Sent: 2/11/2020 9:44:43 AM
Subject: 42 Beatty Street, Balgowlah Heights - DA2020/1263
Attachments: Letter Council 1.1.pdf;

Re: 42 Beatty Street, Balgowlah Heights – DA2020/1263

This submission has been prepared on behalf of Kathy and Ross Taylor, the owner and residents of the neighbouring property to the south at 40 Beatty Street, Balgowlah Heights.

3 ANALYSIS WALL HEIGHT

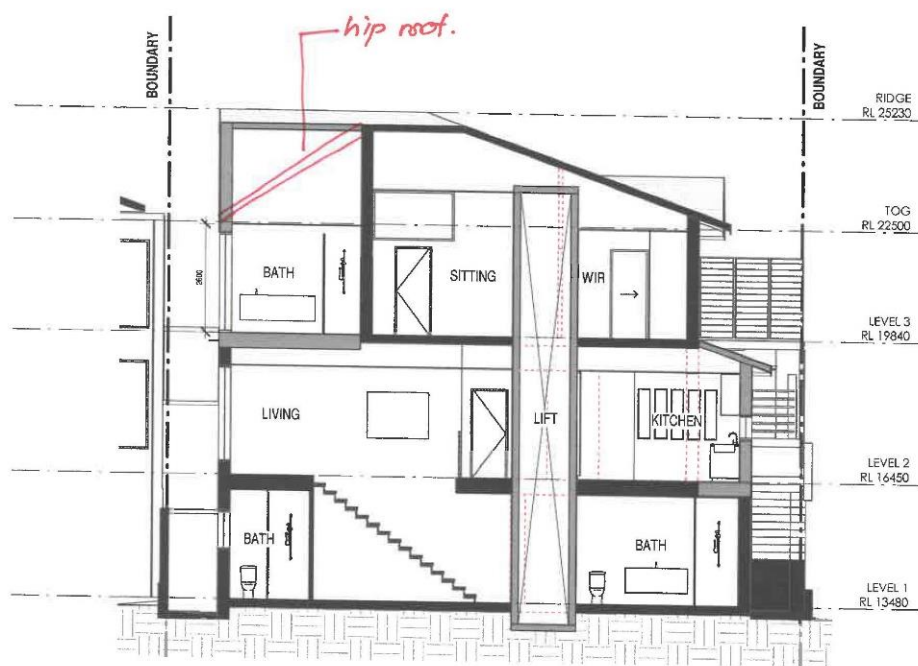
The proposal also breaches the wall height and roof allowance provisions of Part 4.1.2 of the MDCP 2013. IN this regard the applicant's Wall Height Analysis (Drawing A 100 -C) is incorrect.

Firstly, wall height is measured to the underside of the eaves (see definition of “*wall height*” in the Dictionary to MDCP 2013), and this has implications for the calculation of the roof allowance. Secondly, the wall length is incorrectly shown in the diagram. The following is a marked-up version of the diagram that I have prepared that shows the correct calculations:

It can be seen from this analysis that the maximum permitted wall height is 8.0m and the proposal has a wall height of 8.5m. The maximum permitted roof allowance is 2.5m and the proposal has a roof allowance of 3.2m.

1
02 21 SECTION 2
1 : 100

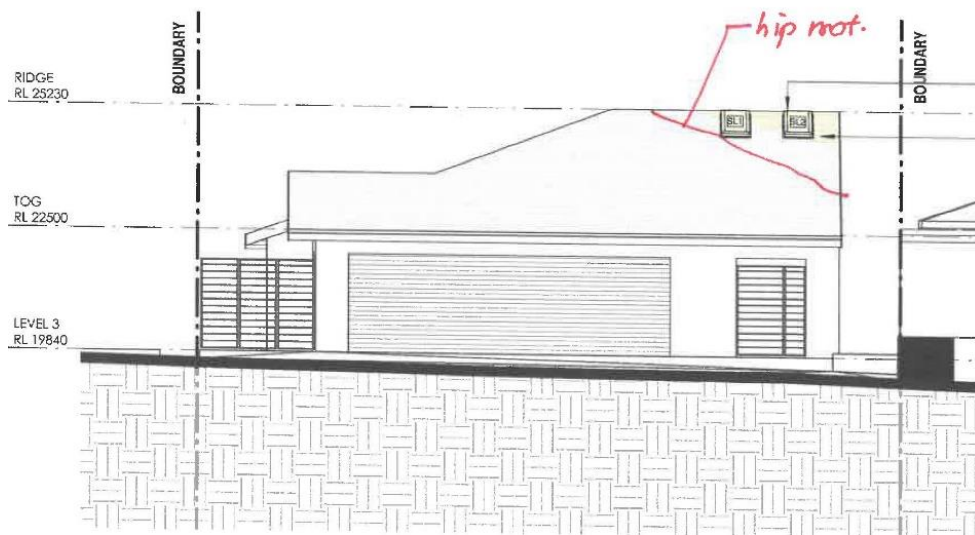
The height, bulk and scale of the building can be mitigated by changing the roof form from a gable end to a hipped roof. In this way the bulk of the roof form would be reduced. It would also result in an aesthetically balanced built form.

The following marked up drawings provide a guide as to how a hipped roof-form could be achieved:
